Grading Plan Approved as shown and/or noted JAMES R. GILLS, P.E. Lake County Engineer

SITE PLAN		
FOR BDR BROTHERS OF SUBLOT NO 56 IN ELLISON CREEK SUBD, CONCORD, OHIO		
SCALE: 1"=20'	APPROVED BY	DRAWN BY: RWC
DATE: MARCH 15, 2002		
AS SHOWN BY THE PLOT RECORDED IN VOLUME 39 PAGE 17 OF C.C.M.R.		
PREPARED BY: RALPH W. KEMPKE PS# 6257 1-440-639-8512		DRAWING NUMBER

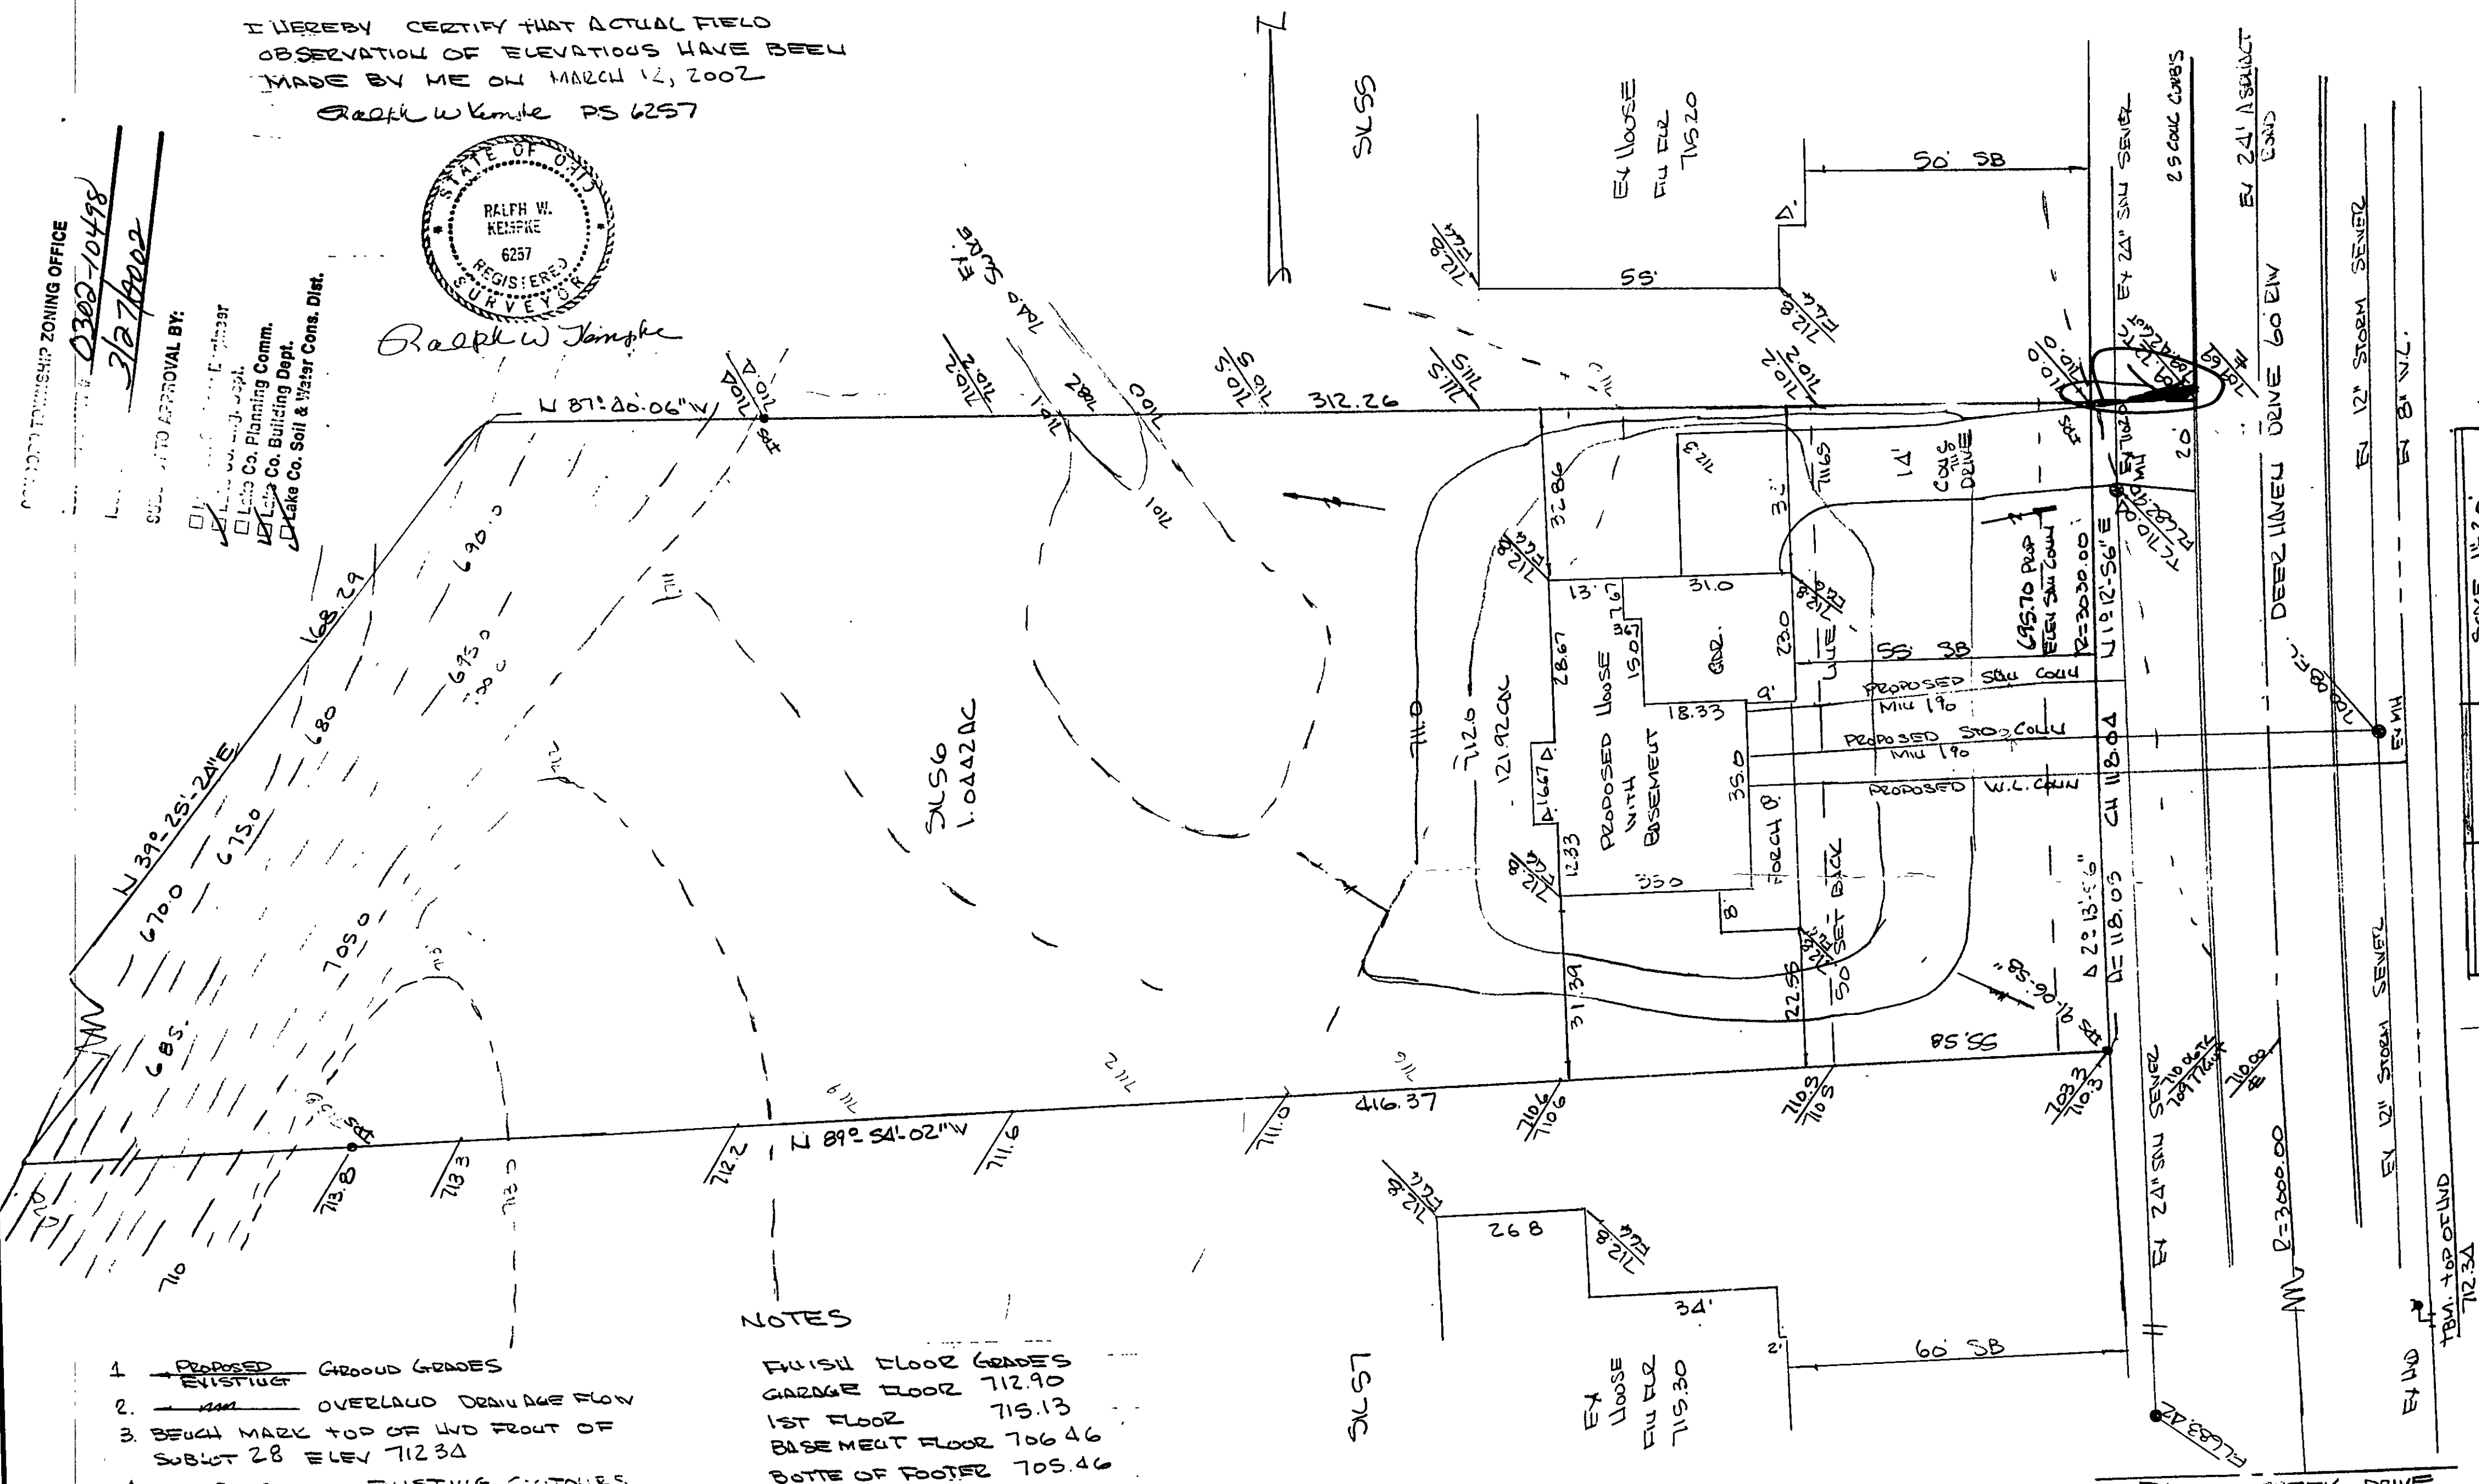
By GLH Date 4/15/02
 Concrete apron must be built in front of Sublot 56 only
